Historic Preservation Board

Request to Deny Certificate of Appropriateness (COA) for Ritz- Carlton (DiLido) | Sagamore

On Behalf of Beach Hotel Associates LLC

December 13, 2021

View Impact

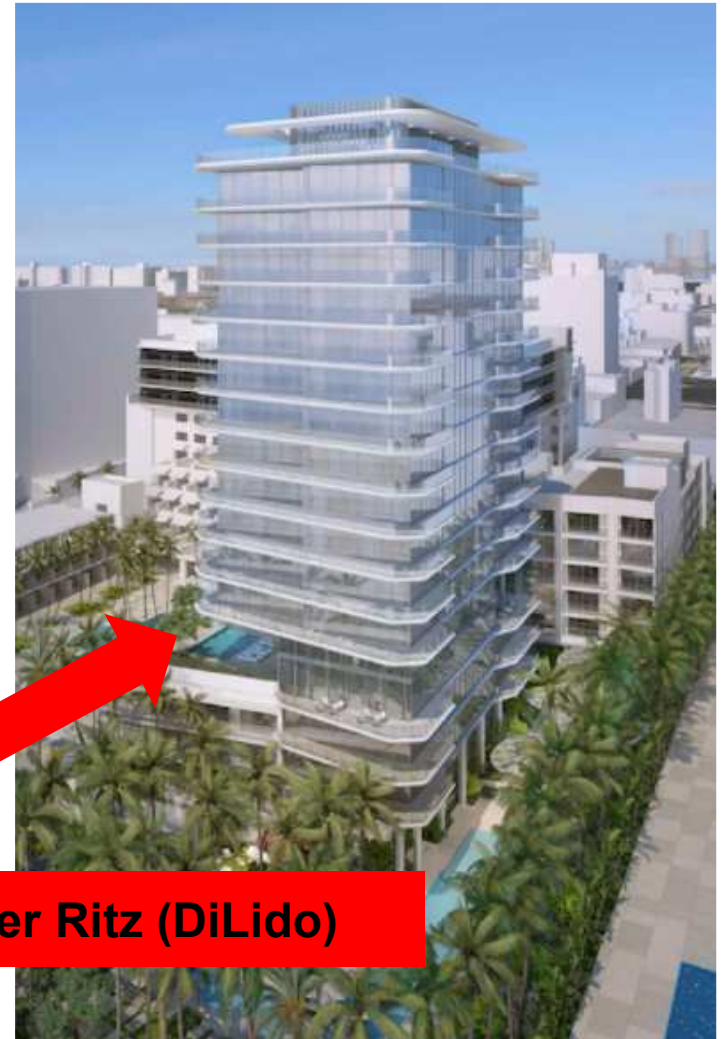
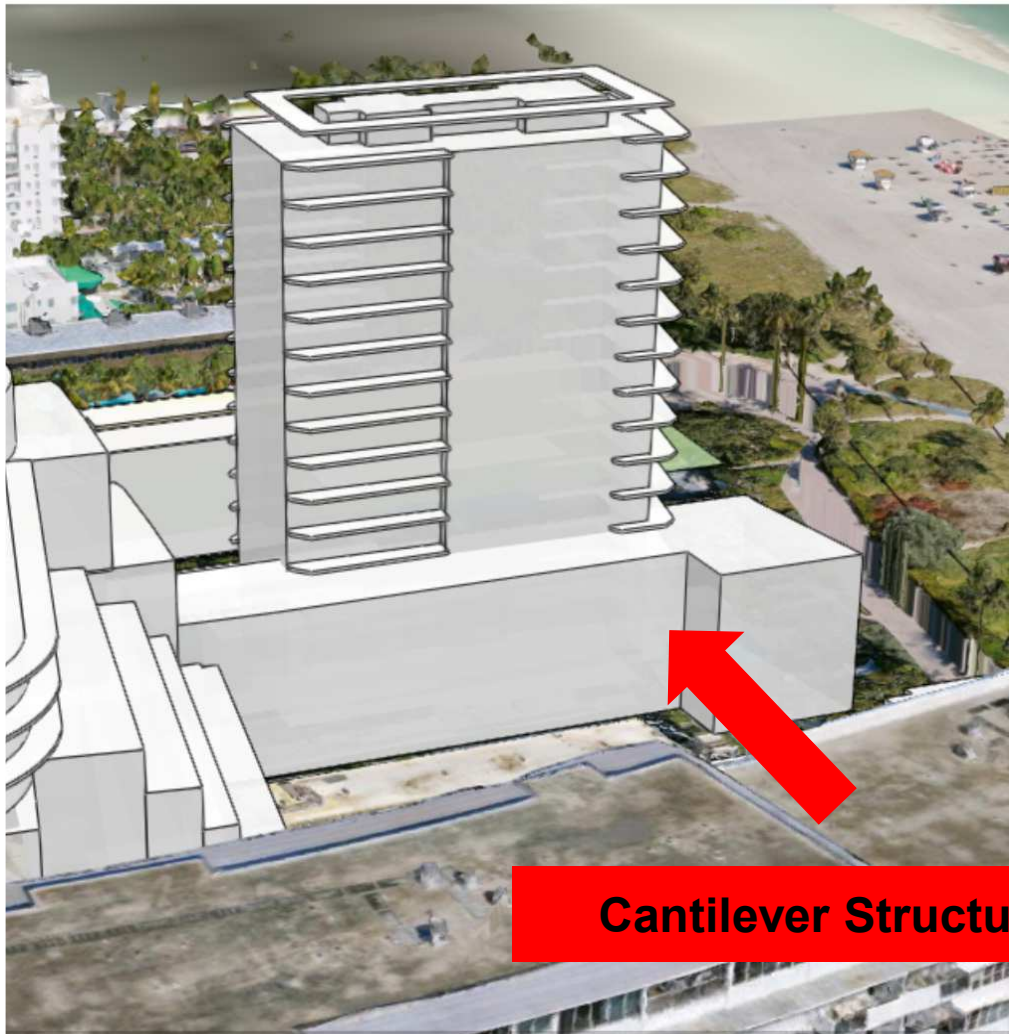
The Applicant Points to Views from Collins Ave, But the Wide Tower Adversely Impacts Views from the South, North and East.

The Applicant Points to Views from Collins Ave, But the Wide Tower Adversely Impacts Views from the South, North and East.

Ordinance No. 2019-4285 at §142-246

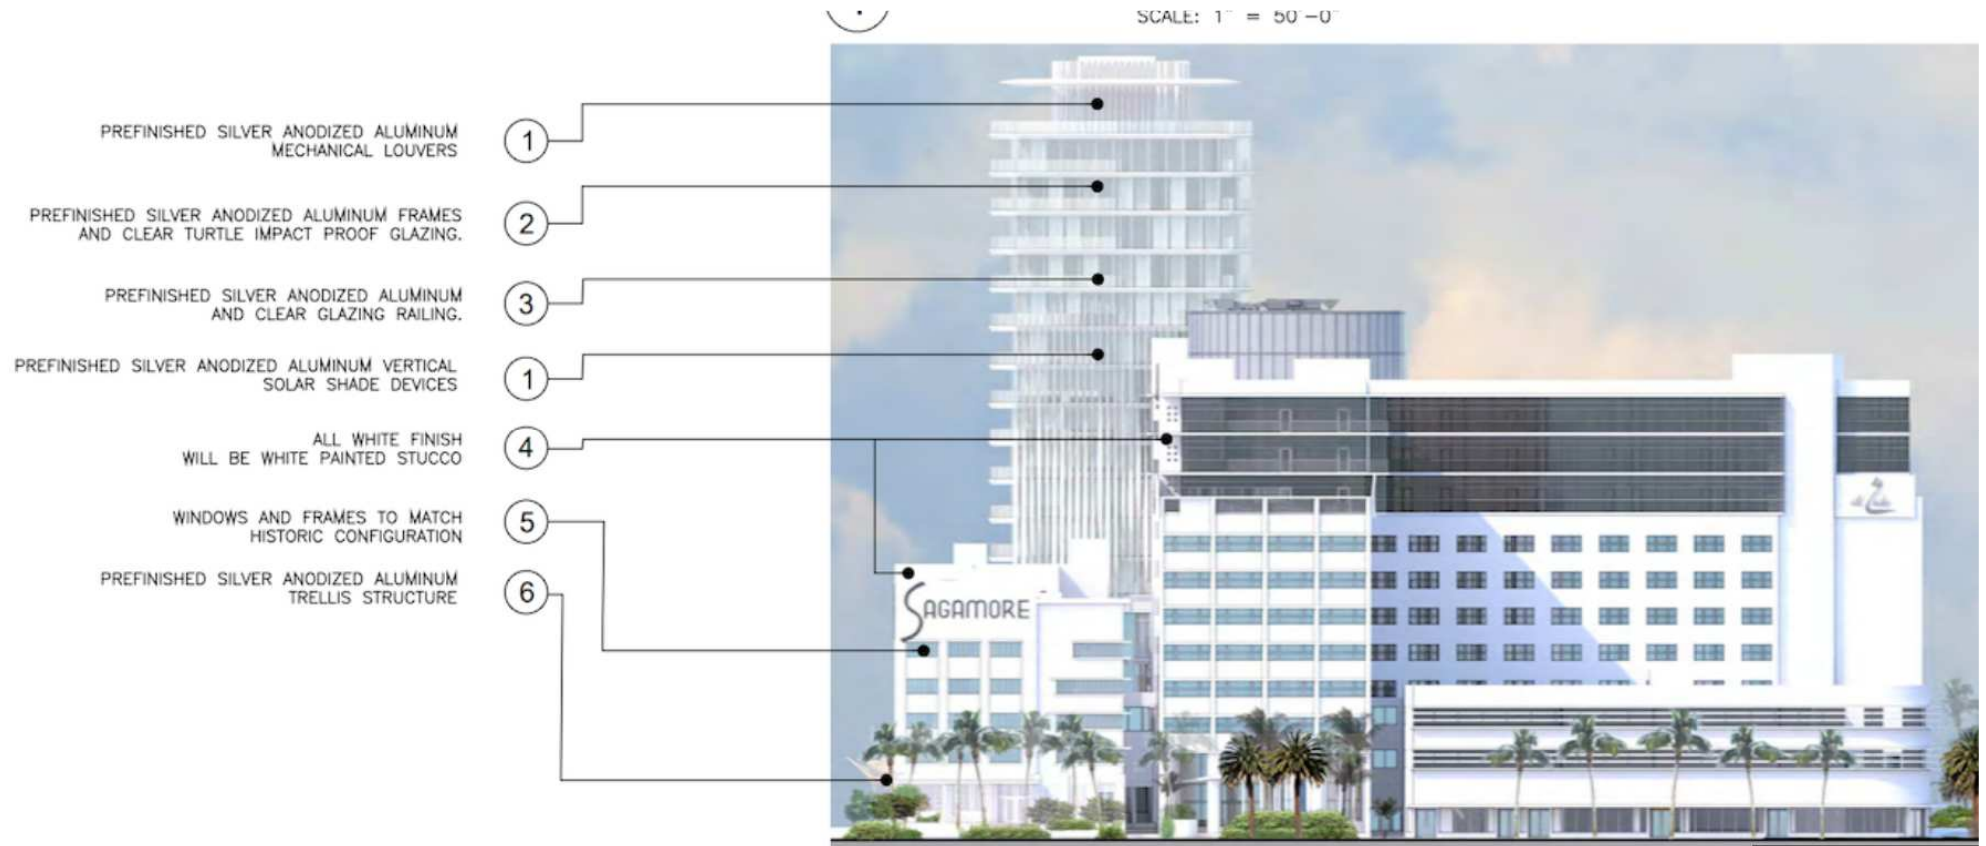
Height **May** Exceed 50 Feet: The 200 Feet Height is Not an Entitlement!

No Mention of **Transferring Height** to Adjacent Combined Property
- *Only lots that are greater than 115,000 SF qualify. Sagamore is only 45,000 SF*

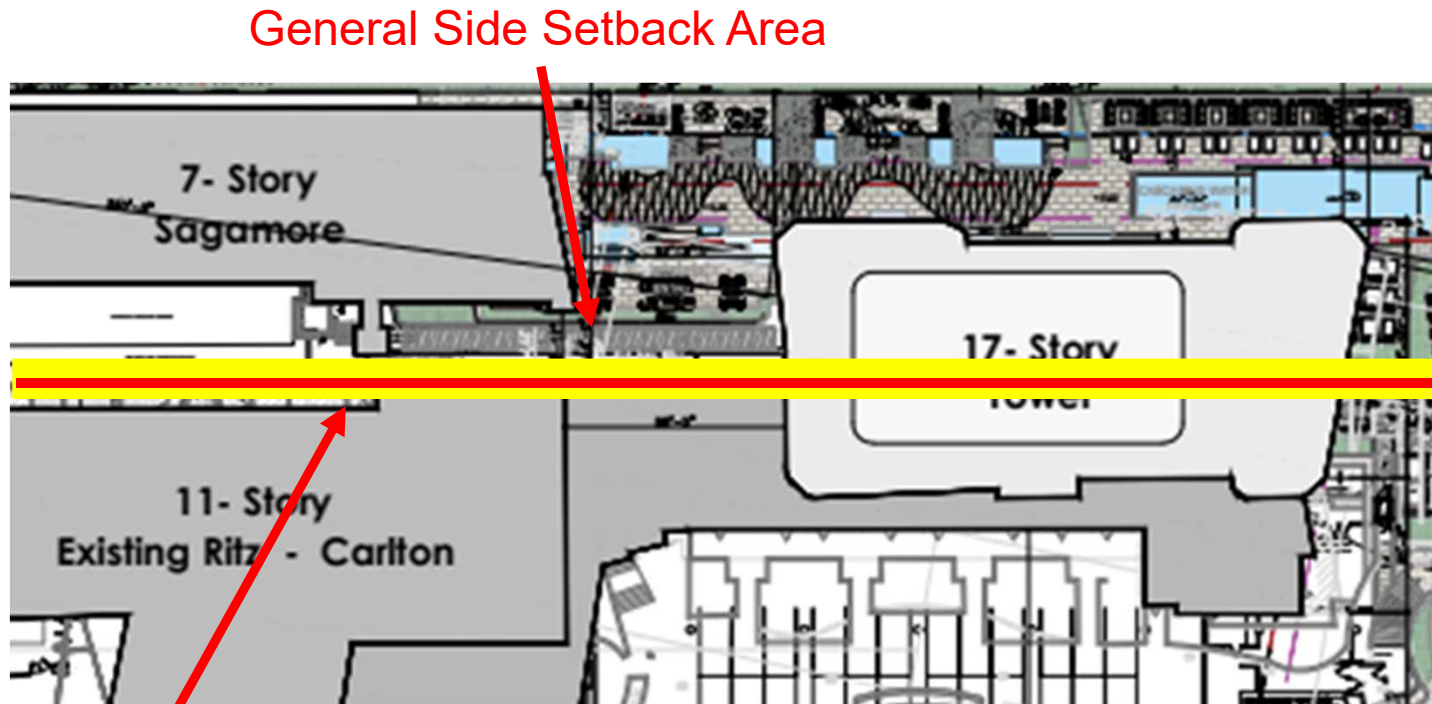
- j. Orientation and massing sensitive to and compatible with the building site and surrounding area and which creates or maintains important view corridors.

Not satisfied due to size, scale and placement of proposed tower.

Shared Property Line Ritz-Carlton (DiLido) | Sagamore

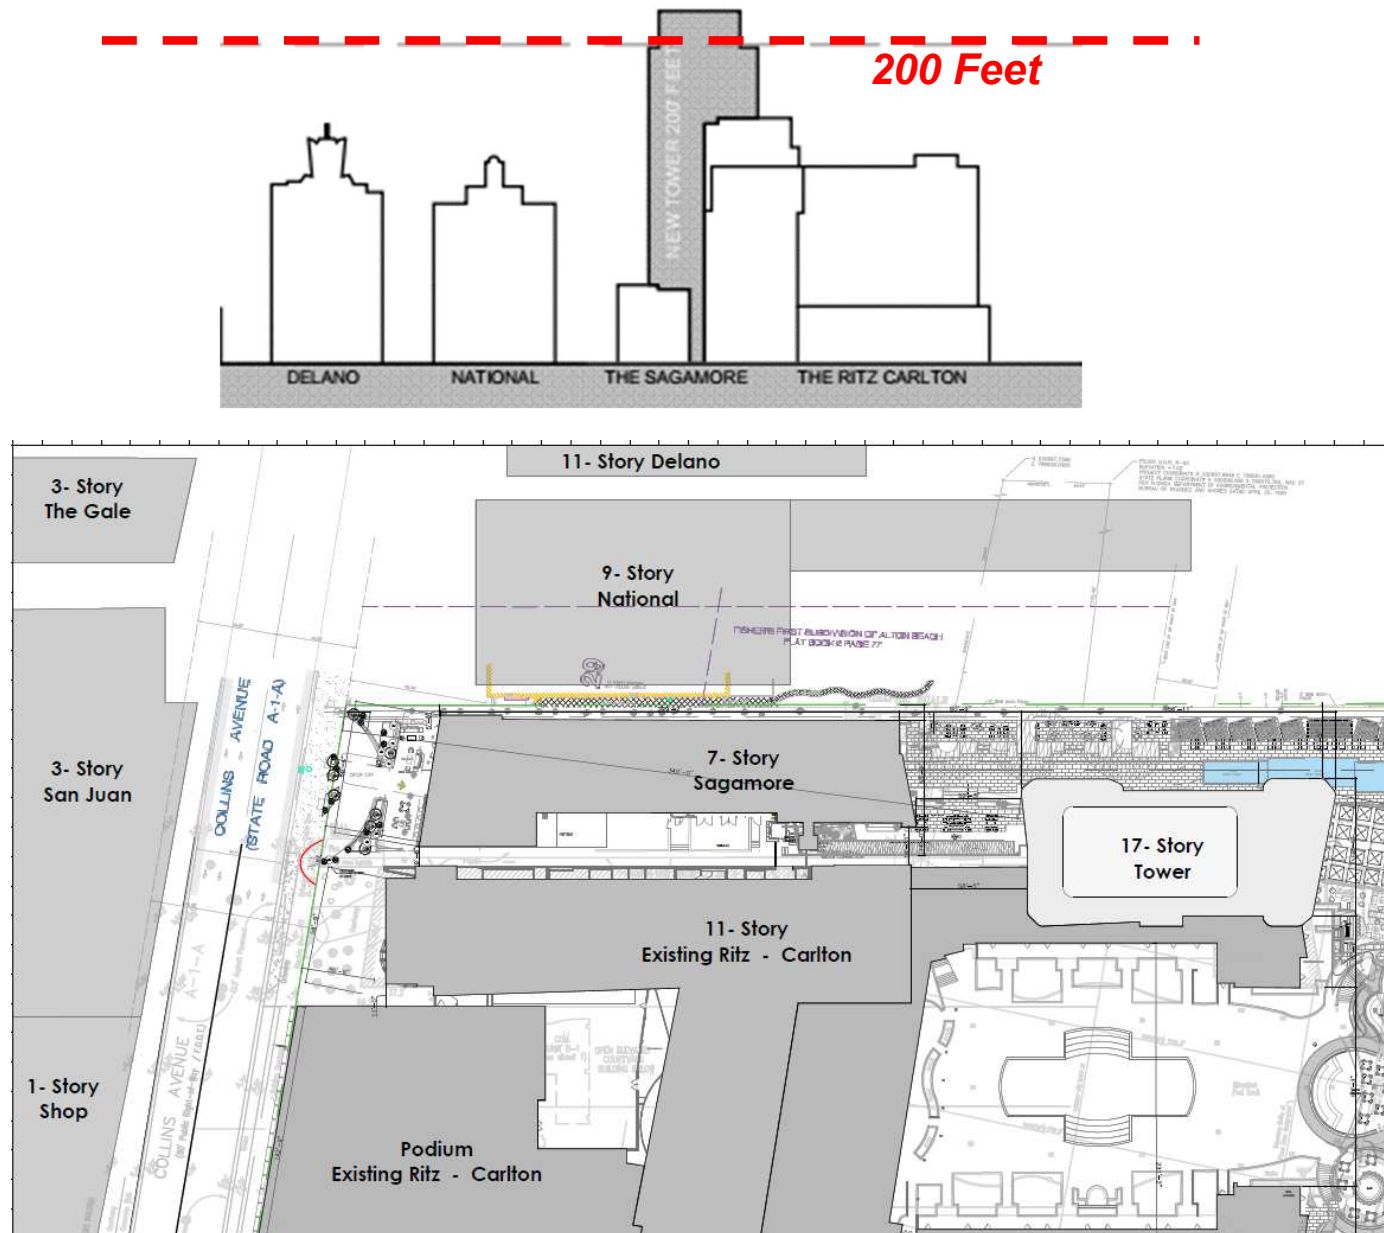
The Ritz-Carlton Site possesses greater Height and FAR, but the bulk of the Tower is on the Sagamore Site

***Tower is Sited in the Existing Setback Between the Two Lots.
However according to applicant the majority of density is on the
Sagamore site***

Setback Compliance

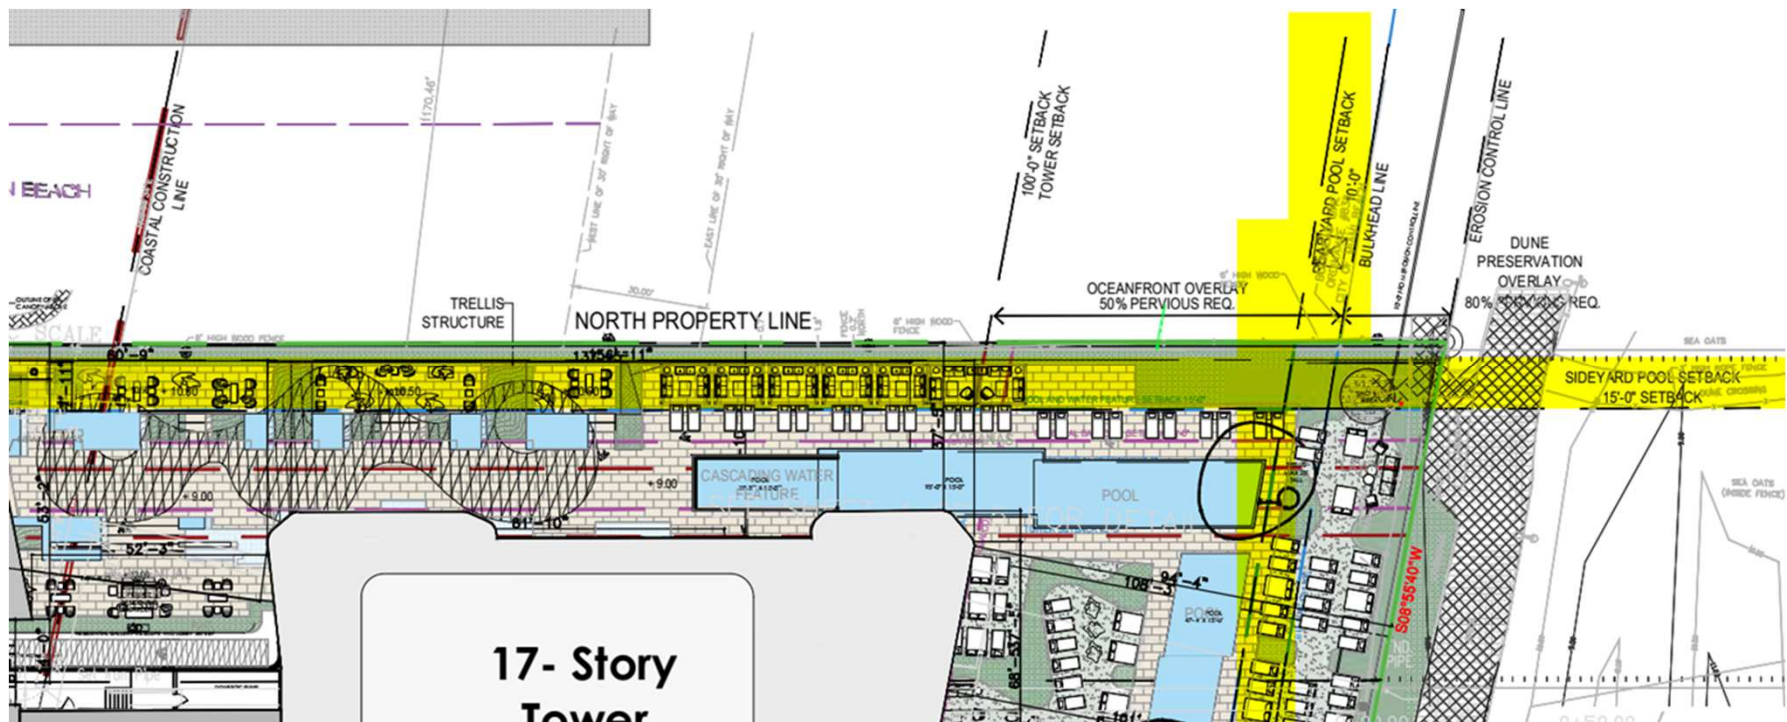
The HPB Staff Report Confirms Non-Compliance with Setbacks, Yet States That “No Variances” are Sought. The Project is Too Massive and Impactful to Allow the Applicant to Kick the Can Down the Road to Building Permit.

1. Section 142-802(3): The pool deck does not comply the minimum required 10'-0" rear setback from the bulkhead line or the minimum required 15'-0" side setback with the Oceanfront Overlay.
